**City of Coral Gables  
CITY COMMISSION MEETING  
February 5, 2013**

**E-1**

Board of Architects Appeal – Application No. AB 12-11-0424

**DMC requested signage location**

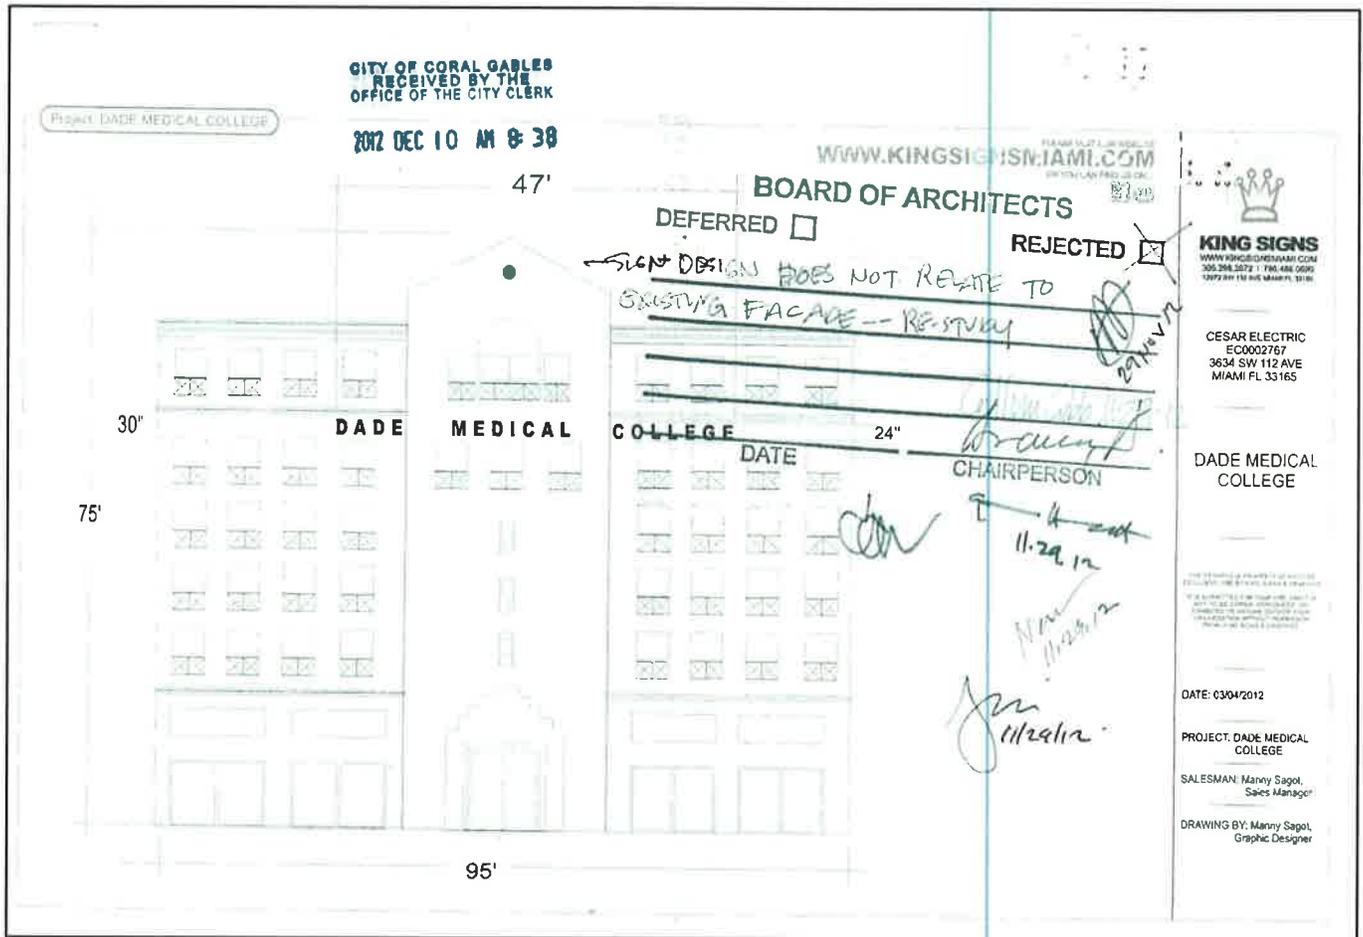
The Dade Medical College sign (illustrated below, on the left) was presented to the Board of Architects at three separate meetings. During the meetings, there was extensive discussion about the aesthetic features of the proposed sign and the impact the sign would have on the appearance of the building.

After considering all the facts presented to them, the Board made several suggestions, including the alternative layout illustrated below (on the right), and an alternative location along Galiano Street. The applicant did not accept the Board’s suggestions and instead chose to resubmit the original design during the third and final meeting. The design was unanimously rejected.

Several members of the Board of Architects expressed concerns about the following issues:

- The sign location was not appropriate, because the center bay of the façade projects forward. Thus, the sign would not be placed on a flat wall, a feature that detracts from its design integrity.
- The design of the sign did not complement the architecture of the building in terms of the overall length, spacing of the letters, and color.
- There are alternative locations where a sign would be more compatible with the architecture of the building.

The Board made several suggestions, in an effort to enhance the aesthetic quality of the sign. The following alternative options were recommended:

- Locate the sign on the Galiano Street façade (instead of Merrick Way).
- Group the three words and logo and locate the entire sign on the central tower element of the building.
